Pentium[®] II Processor Specification Update

Release Date: November 1997

Order Number: 243337-007

Figure 7. S.E.C. Cartridge Bottom Side View

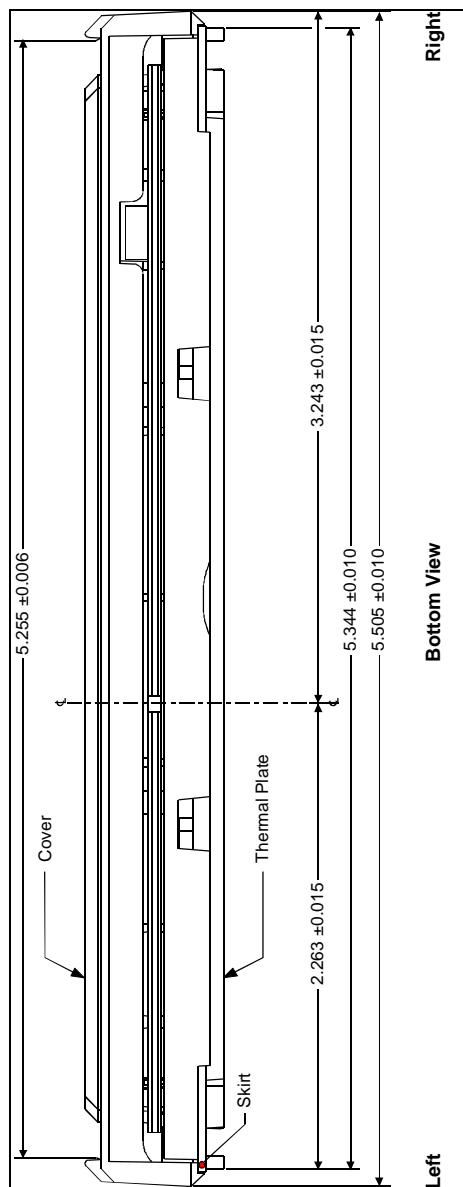
** Added Figure 9, Figure 7 corrected a dimension, Figure 8 clarified dimensions, Figure 10 corrected dimensions

Figure 11. S.E.C. Cartridge Mark Locations
(See Table 1 For Processor Markings)

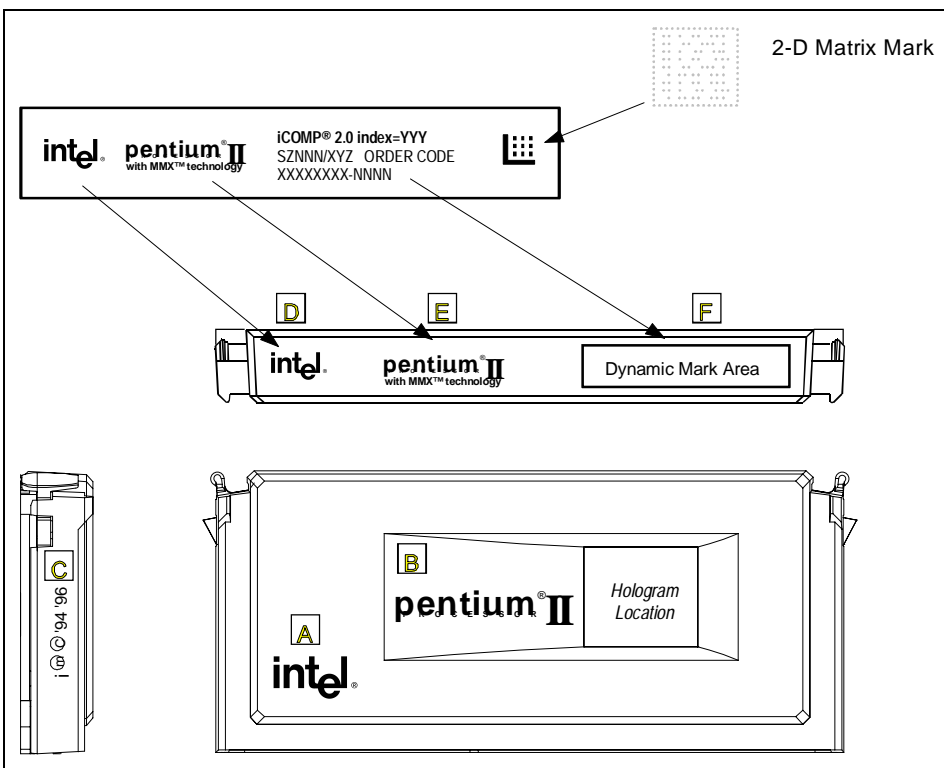
A change to the attach mechanism specification is provided below. The original specification for clearance of heatsink attach solutions is provided in Section 4.3 (and Figure 23 and Figure 24) in the *Pentium® II Processor at 233 MHz, 266 MHz and 300 MHz* datasheet. Figure 11 shows the revised maximum specifications for heatsink clip and RivscREW® attach mechanism designs. All heatsink clip and RivscREW attachment solutions must remain within the respective maximum “permissible” zone as detailed in Figure 11.

The thermal plate shown in Figure 11 is used to portray the heatsink attach mechanism design space for the future Slot 1 processors. However, the maximum “permissible” design space is also valid for both the current Pentium II and future Slot 1 processors.
